Modification Bulletin

Model: Pomelo			Date	e: 30-Apr-99			
Modified Article: P	Parts Catalog			Prepared by: H. Someya			
From: Technical Ser	rvice Dept., GTS Division						
Reason for	Parts catalog correction	U Vend	dor ch	hange 🗌 To meet standard		neet standards	
Modification:	To facilitate assembly	To improve reliability ())			
	Part standardization	🗌 Othe	r

Model: Pomelo			Date	e: 30-Jun-99	9	No.: MG033002
Modified Article: P	Parts Catalog			Prepared by: H. Someya		
From: Technical Sei	rvice Dept., GTS Division					
Reason for Modification:	 Parts catalog correction To facilitate assembly Part standardization 	U Vend To in Othe	nprove	ange e reliability	□ To n (neet standards)

Model: Pomelo	el: Pomelo Date: 15-Aug-99				9	No.: MG033003		
Modified Article: C	fied Article: Optical Unit			Prepared by: H. Someya				
From: Technical Ser	rvice Dept., GTS Division							
Reason for	Parts catalog correction	U Venc	lor ch	hange 🗌 To meet standard		neet standards		
Modification:	To facilitate assembly	🖂 To improve reliabilit		e reliability	()		
	Part standardization	Part standardization

Illustration for page 3

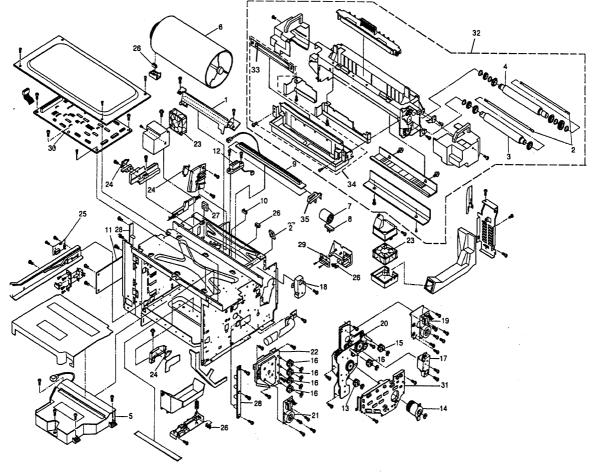
The following parts have been registered as service parts:

Old part	New part	Description	Qty	Int	Page	Index	Note
number	number						
	V126534	Actuator – Transfer Unit	1		3	11	*1
	V126531	Wedge – 3 pcs	1		3	12	*1
	V126529	Oil Felt – Fusing Roller	1		9	33	*1
	V126530	Oil Pan Unit	1		9	34	*1
	V126533	Quenching Lamp Holder – 2 pcs	1		9	35	*1
	G0296845	Decal – Aficio *2	1		17	5	*1

Illustration for page 9

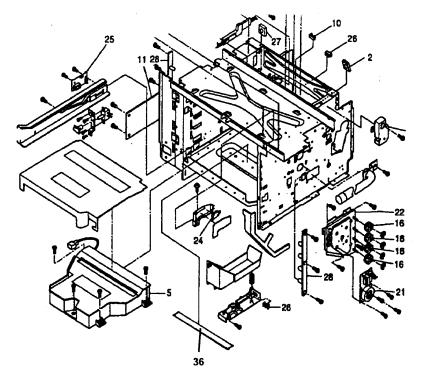
To prevent dust from entering the optical unit, polyester tape has been attached to block the holes in the base.

Old part number	New part number	Description	Qty	Int	Page	Index	Note
	V126239	Polyester Tape – 20 pcs	1		9	36

Note: The above part contains 20 pieces of tape (as one set).

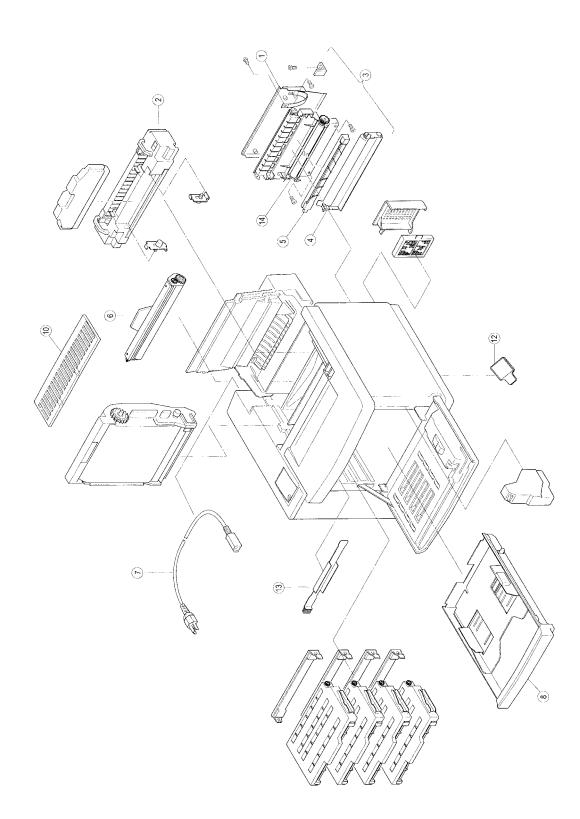
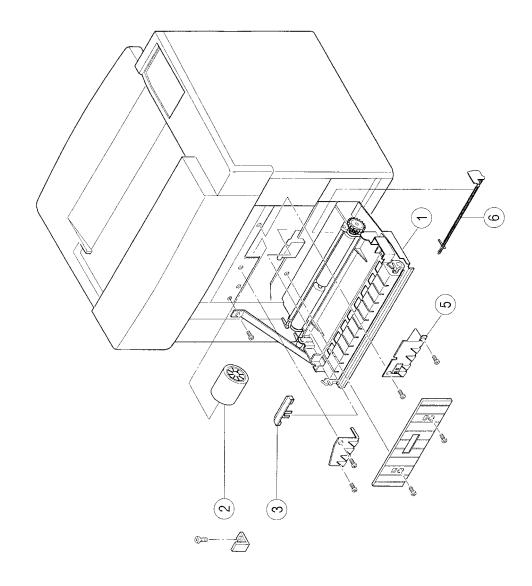
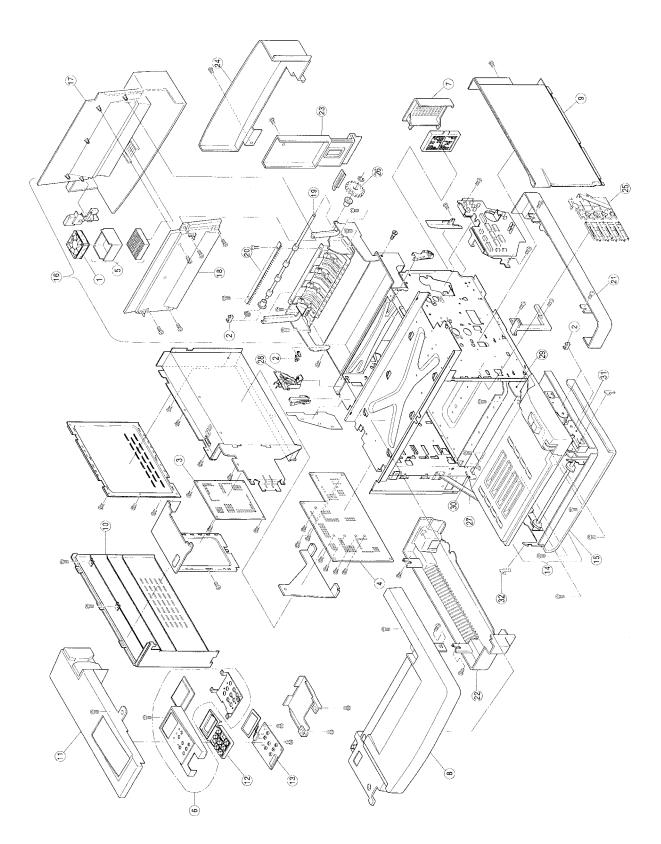
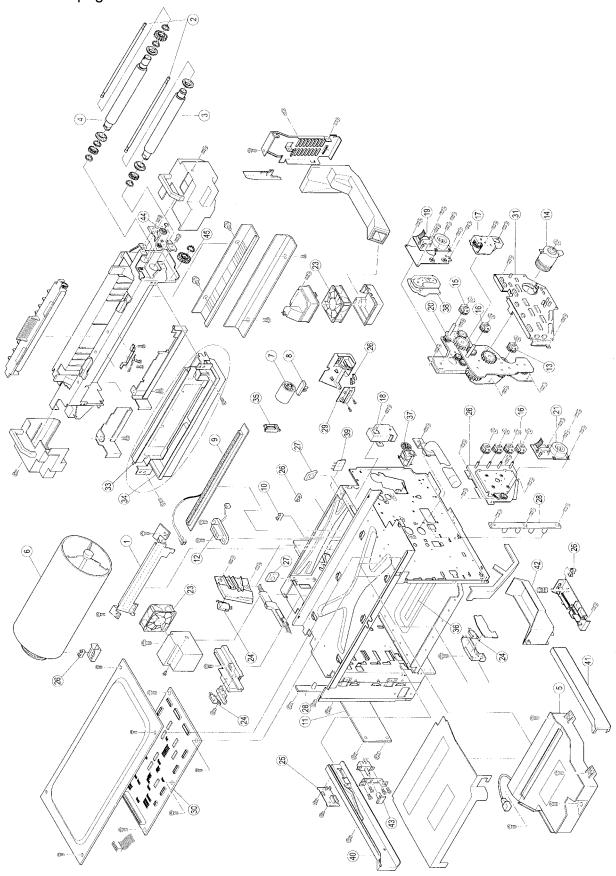
The following parts have been registered as service parts:

Nowport	Description	Q'ty	Int	Daga	Index	Noto
New part	Description	Qty	IIIL	Page	muex	note
number						
V126536	BC Wire Cleaner	1		3	13	
V126190	TR Regist Roller	1		3	14	
V126574	Paper Guide L (UP) 2	1		5	5	
V126534	Actuator – Transfer Unit	1		5	6	
V126539	S Plate Assy	1		7	25	
V126577	HP Idle Z17 (2)	1		7	26	
V126426	DE Hinge Arm	1		7	27	
V126180	BC Terminal	1		7	28	
V126185	Front Stay R	1		7	29	
V126186	Front Stay L	1		7	30	
V126427	DE Solenoid Assy	1		7	31	
V126192	F Lock Cover	1		7	32	
V126168	Belt Sensor	1		9	27	*1
V126188	Lower Waste Toner Feeder	1		9	37	
V126199	MD Gear Ass'y	1		9	38	
V126247	Paper Guide D – 2 pcs	1		9	39	
V126200	Left Cassette Guide	1		9	40	
V126201	Right Cassette Guide	1		9	41	
V126540	WT Holder Assy	1		9	42	
V126541	SW Button	1		9	43	
V126575	FUCR Gear	1		9	44	
V126576	FU Gear 33	1		9	45

*1: The index number of belt sensor in the illustration has been corrected.
